Subj: U.S. 62 Highway Bridge, Mile 392.5, Arkansas Waterway

BRIDGE PERMIT

NAVIGATION LIGHTING PLAN U.S. 62 HIGHWAY BRIDGE **ARKANSAS WATERWAY** MILE 392.5

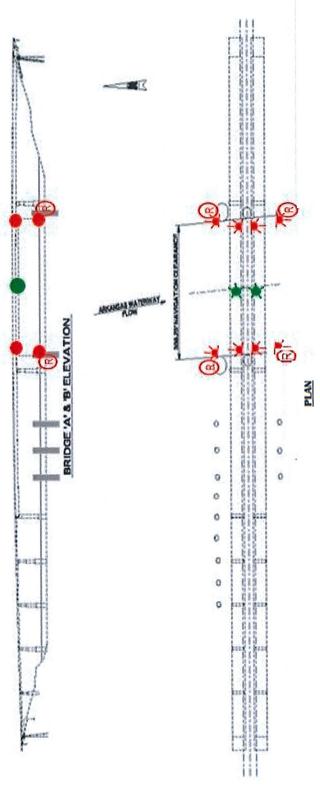
¥ = 360 DEGREE GREEN CHANNEL CENTER LIGHT

= 180 DEGREE RED MARGIN OF CHANNEL LIGHT AND PIER PROTECTION CELL LIGHTS

R = RED RETRO-REFLECTIVE PANEL

The center of the channel shall be marked by a range of two green lights. Each green light shall show through a horizontal arc of 360 degrees and shall be security mounted just below the outermost edge of the bridge span structure in line with the axis of the channel so as to be visible from an approaching vessel.

The upstream and downstream sides of the channel margins shall be marked with red lights. Each red light shall show through a horizontal act of 180 degrees and shall be securely mounted no higher than the green navigation lights to show 90 degrees on either side of a line parallel to the axis of the channel so as to be visible from an approaching vessel.

Each pier protection cell shall be marked with a red light. Each red light shall show through a horizontal arc of 180 degrees and shall be securely mounted to the top of the cell on the channelward quadrant of the cell to show 90 degrees on either side of a line parallel to the axis of the channel so as to be visible from an approaching vessel.

The upstream and downstream sides of the channel pier protection cells shall be marked with red, high-intensity grade, retro-reflective square panels which measure 2 feet per side. This retro-reflective material should be placed near the top of the piers on the columns or pier caps so as to effectively reflect the searchlight of an approaching vessel.
